**Pacific Gas and  
Electric Company**

PG&E Letter DCL-06-008

Docket No. 50-275, OL-DPR-80  
Docket No. 50-323, OL-DPR-82  
Diablo Canyon Units 1 and 2  
License Amendment Request 06-01  
Revision to Technical Specification 1.1, "Definitions," and Technical  
Specification 3.4.16, "RCS Specific Activity"

Figure 3.4-1  
DOSE EQUIVALENT I-131 REACTOR COOLANT SPECIFIC ACTIVITY LIMIT  
VERSUS PERCENT OF RATED THERMAL POWER WITH THE REACTOR COOLANT  
SPECIFIC ACTIVITY > 1 µCi/GRAM DOSE EQUIVALENT I-131

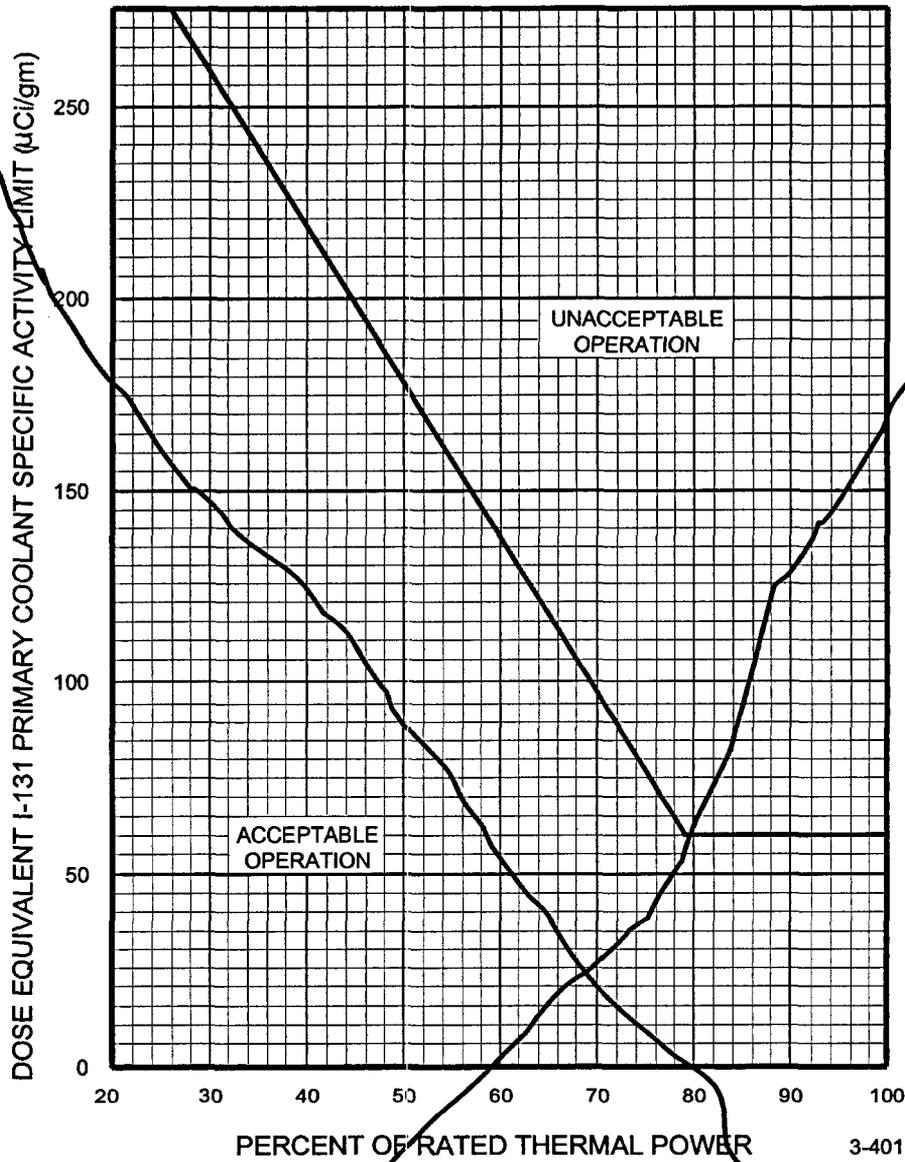
The current TS Figure 3.4.16-1, "Dose Equivalent I-131 Reactor Coolant Specific Activity Limit Versus Percent of Rated Thermal Power with the Reactor Coolant Specific Activity > 1  $\mu$ Ci/gram Dose Equivalent I-131" would be deleted.

TS 3.4.16 Required Action A.1 is modified to remove the reference to Figure 3.4.16-1 and insert a limit of less than or equal to 60  $\mu\text{Ci/gm}$  for DEI.

The curve contained in Figure 3.4.16-1 was initiated by the AEC in a June 12, 1974, letter from the AEC on the subject, "Proposed Standard Technical Specifications for Primary Coolant Activity." However, this letter does not provide any technical basis for the curve.

The Case 2 radiological consequence analyses for SGTR and MSLB accidents that take into account the preaccident iodine spike do not consider the elevated RCS iodine specific activities permitted by current TS Figure 3.4.16-1 for operation at power levels below 80 percent RTP (i.e., DEI of 60  $\mu\text{Ci/gm}$  at 80 percent RTP increasing linearly to [275]  $\mu\text{Ci/gm}$  at [25] percent RTP). Instead, the Case 2 analyses assume a DEI concentration 60 times higher than the corresponding accident's Case 1 analysis assumption, [which corresponds to the 60  $\mu\text{Ci/gm}$  specific activity limit associated with 100 percent RTP operation as discussed in Section 3.1 above]. Therefore, TS 3.4.16 Required Action A.1 should be

Delete Page

based on a limit of 60  $\mu\text{Ci/gm}$  to be consistent with the assumptions contained in the radiological consequence analyses. It is not expected that plant operation at reduced power levels would result in iodine specific activity levels that exceed the 60  $\mu\text{Ci/gm}$  upper limit defined for full power operation.
